Section 8.00 & 9.00 comprises point-by-point responses to both the Pre-Application Advice provided by MSDC dated 17th November’23 ref: DM/23/1480 and advice provided by Place Services dated 12th November ’25 ref. DM/25/0133. In addition, responses to the Conservation Officer comments raised on 5th June 2026 are also included in this section.

SECTION 8.00-9.00 Planning Pre-App’s DM/23/1480 & DM/25/0133

Responses to and Comparables with Current Full Planning/Listed Building Consent Applications
(including response to Conservation Officer Comments 05.06.26)

8.04 New Leisure Facilities - Pool/Spa/Gym/ Yoga: Lower Ground / Ground Floor (nts)

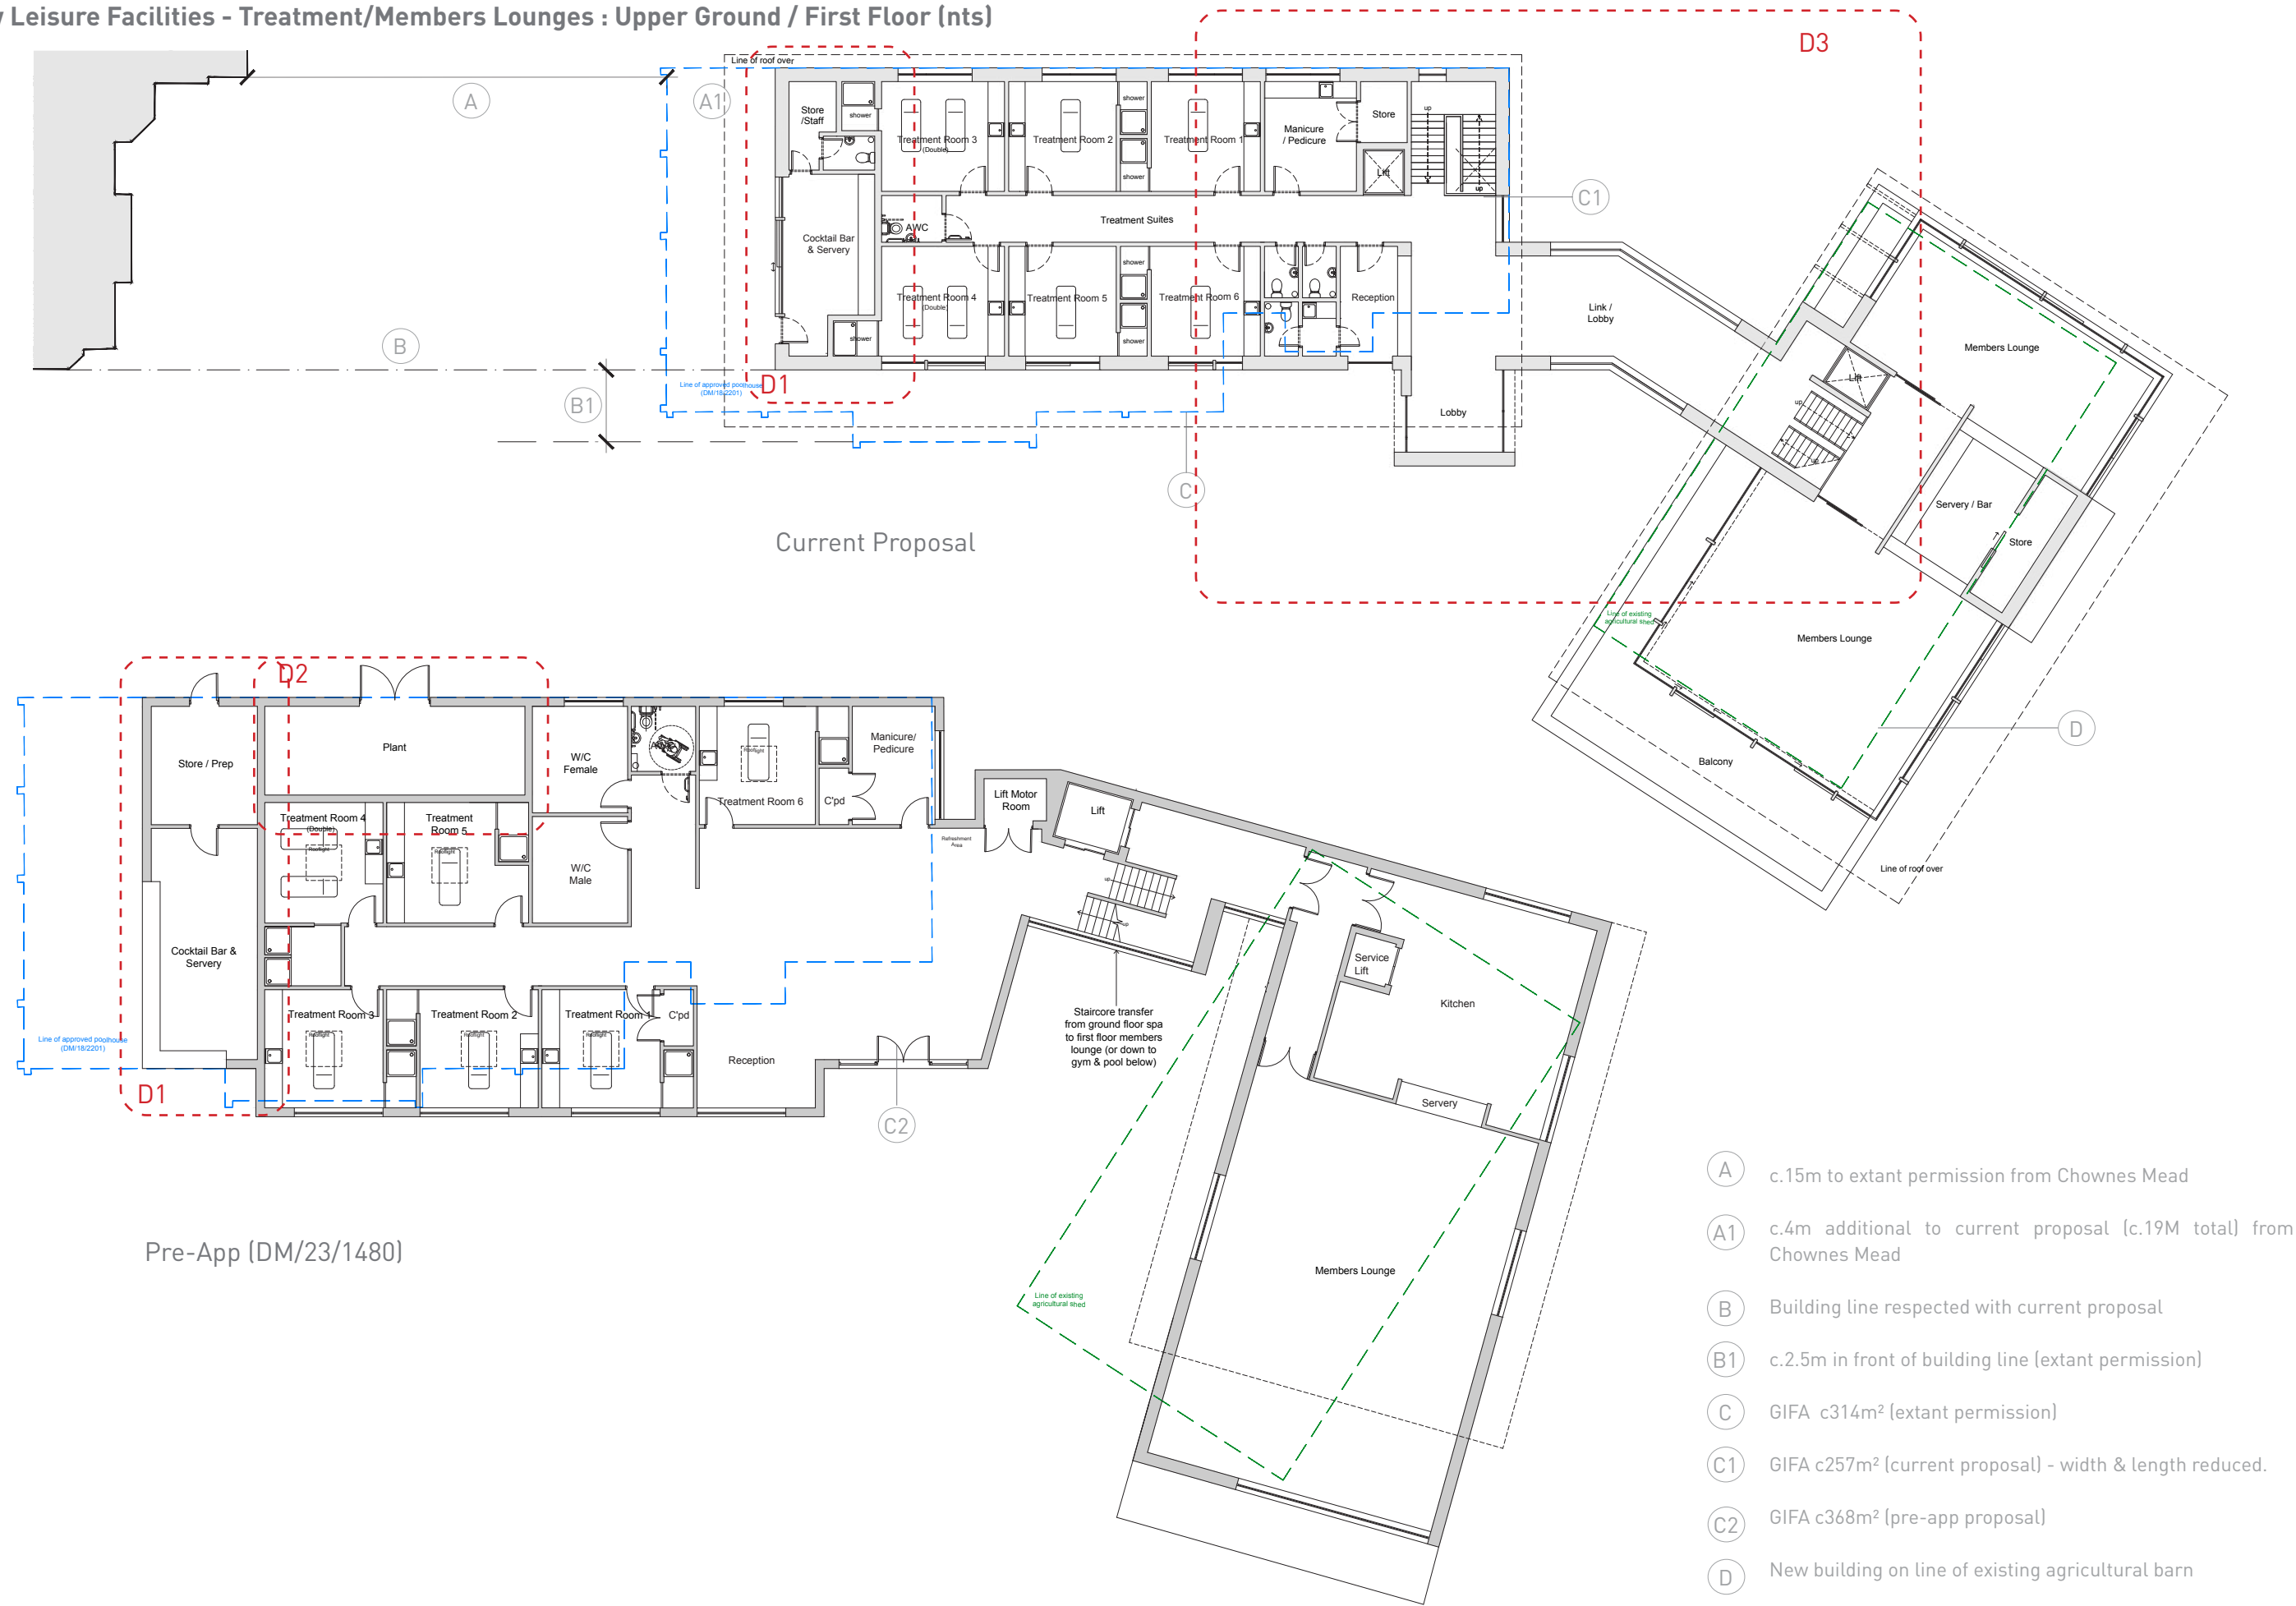
D1
‘The proposed two storey pool and treatment room building is a more substantial structure than the approved pool house. However, the building is set further away from the listed house, creating greater separation between the two, and the additional storey is set below the terrace, taking advantage of the drop in the levels of the gardens to the south west of the house.’
‘In my opinion, this approach is not necessarily contentious in principle, but the building and surrounding landscaping will require very careful planning and detailing, including the choice of materials, to minimise the bulk and visual prominence of the development in the context of the house, ensure that it complements rather than detracts from the house and its setting, and to preserve the character of the Jekyll designed gardens, including the existing listed terrace walls. The submitted visuals, which I appreciate are only conceptual, show for example a rather stark treatment of the retaining wall to the north west of the pool house itself, continuing along the house’s garden frontage. We would expect a more sensitive treatment with appropriate detailing and planting to blend the built form into the landscape, and not to detract from or compete with the original listed terrace walls. I also wonder whether the cocktail bar and servery to the north west end of the ground floor of the building is necessary in this form and position, particularly given the proximity of the house, or could be omitted or relocated to reduce the bulk of the building.’

D2
‘Firstly, I do have concerns about the potential noise generated by the plant associated with the spa and gym. To adequately assess this issue, we would require detailed information about the proposed plant, its location, whether it is internal or external, and any measures that will be implemented to mitigate noise. Depending on the expected noise breakout, we may need to request an acoustic report to ensure that the noise levels will not adversely affect the surrounding area.’

D1
Subservience & Separation
As noted in the pre-app response, the upper level of the proposed spa and pool building is set c.4M further away from the listed building than the extant permission. The intention is to create a greater separation between existing and new build elements, reinforcing the subservience of the new buildings, the current proposal widening this gap to c.19M overall.

Quantum
In contrast to the planning pre-app, the treatment suites and spa / pool building has been considerably reduced in overall size at the upper (terrace) level by c.111Msq. (pre-app. c.368Msq and current c.257Msq).

D2
The refined and reduced layout of the treatment suites and pool / spa building has enabled a reworking of the plant areas which were positioned towards the north west end of the building at the upper floor level in the pre-app submission. The current layouts propose repositioning this element below ground to the south eastern end of the building to mitigate any noise breakout impacts from the plant area that would potentially impact the guests of the listed building or neighbours.

The position, scale and form of the link lobby between the two elements of the proposal has been reconsidered, with the revised structure reduced by around 30Msq overall and in turn set back (further to the north east) between the buildings rather than projecting southwards of the upper floor of the pool building.

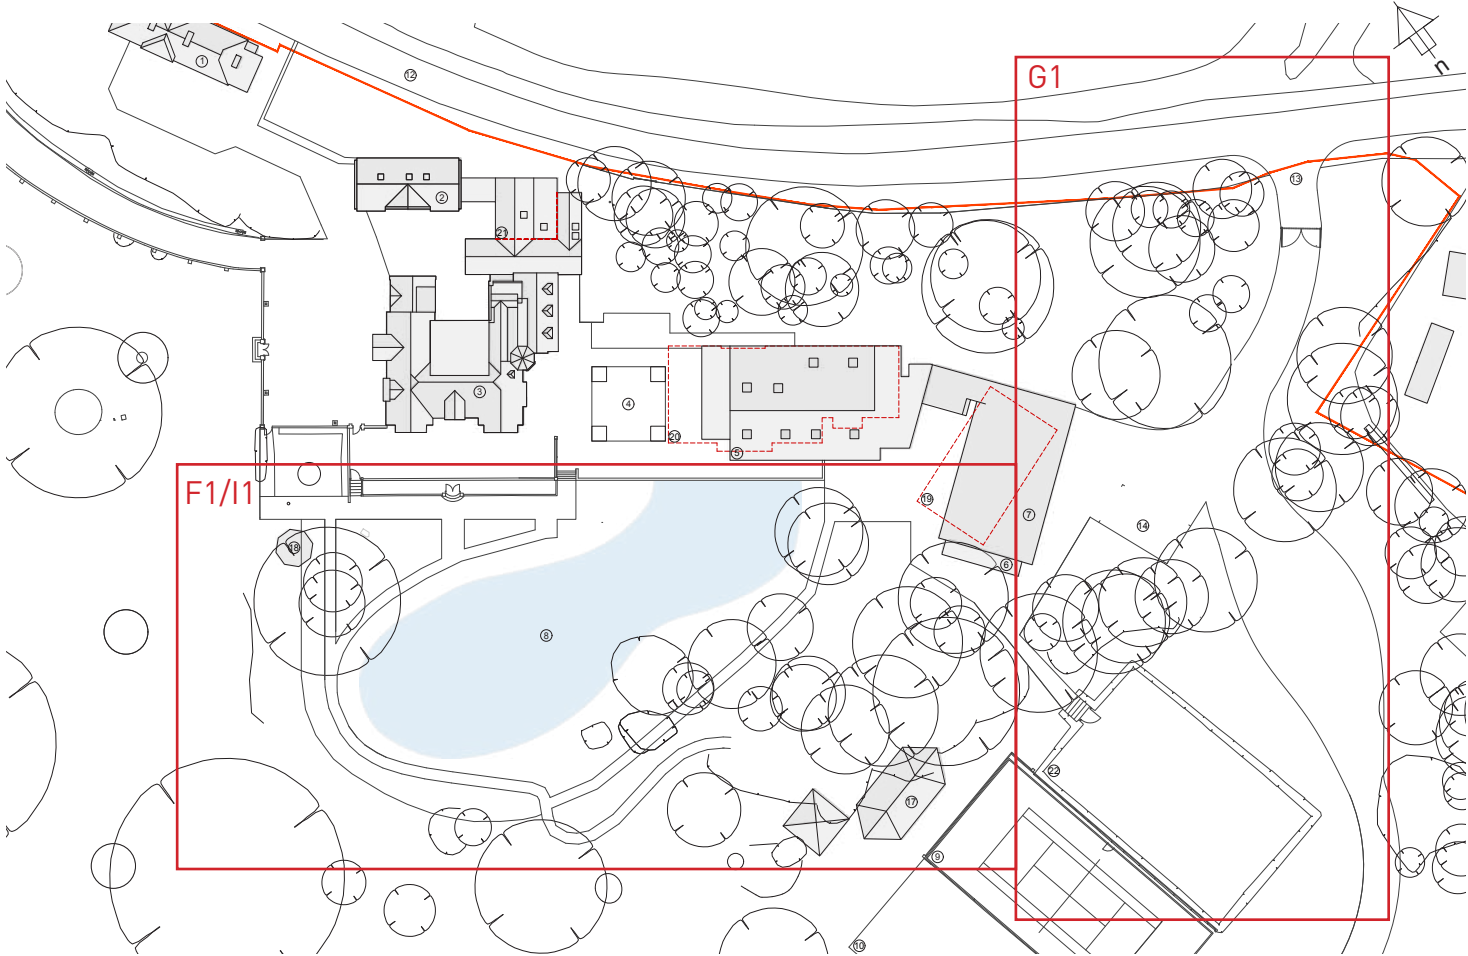
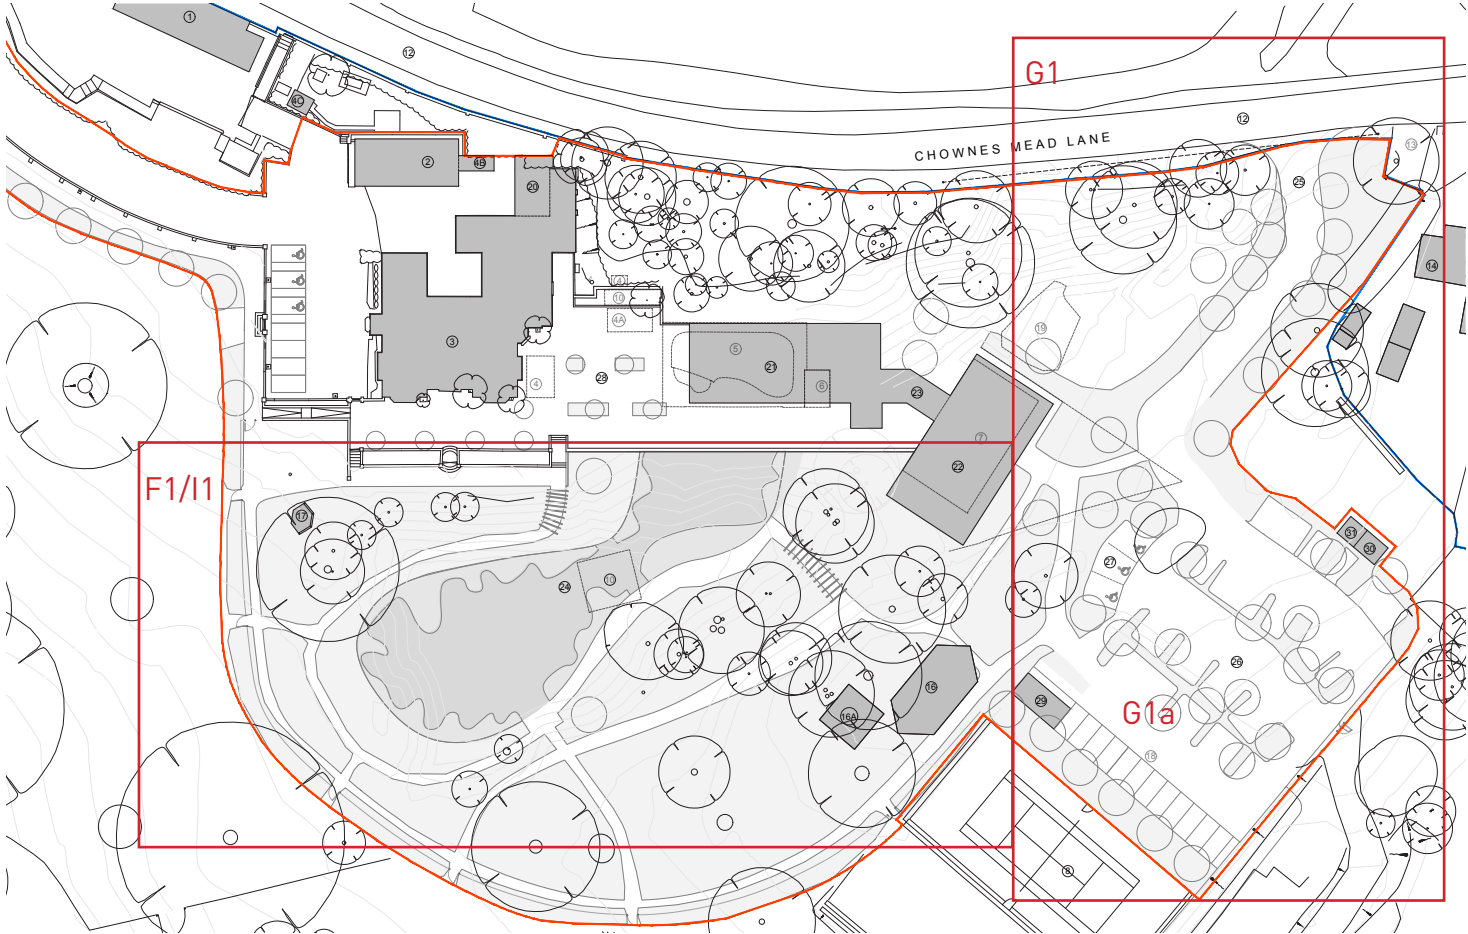
'The reinstatement of the pond within the dell is not considered contentious, and may be considered beneficial, if this is shown to be part of the original Jekyll plans for the garden, and in particular if accompanied by other, appropriately informed, restoration of historic garden features/plantings.'
- G1

'The relocation of the secondary entrance from Chownes Mead Lane is not considered contentious subject to detail including of the impact on any planting/trees to the boundary. Likewise the proposed parking area may be acceptable subject to detail, given the existing hard standing in this position. A detailed hard and soft landscaping scheme would be required to demonstrate that there is no adverse impact on the garden setting of the house.'
- I1

'Upon visiting the site, it was apparent that the pond area still possesses considerable depth, so it is unclear how much made ground could have actually been placed. However, I would still advocate for a phased approach to address this concern. Given the planned redevelopment of the site, I would recommend, at the very least, conducting a desktop study to determine whether any further investigation or remediation efforts are necessary. This phased approach, including the need for a preliminary study, can be conditioned if there is a desire to obtain permission before commencing such an in-depth investigation.'

Reference should be made to all drawings and documentation by Nicholas Dexter Landscaping Design in conjunction with the proposed pond within the dell as well as the Jekyll influenced sensitive landscaping and garden design which marries with the architectural approach, responding wholly to the listed building and heritage setting.
- G1

The suggestion of a phased approach and Condition applied to this is acknowledged and agreed as the most sensible way to approach this element.
